Access Compliance Report

Public Rights-of-Way

(Pedestrian Signals)

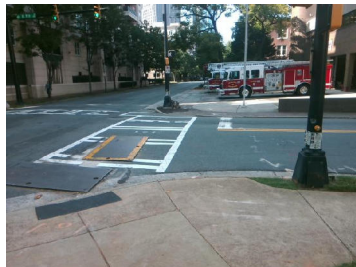
Surveyor Notes: TXT HT 5/16

PROW/ADA: R410.6, R404.2, R404.3, R406.2

Possible Solutions: Remove & Replace Sign. Provide Push Button Extension. Remove and Replace Clear Space.
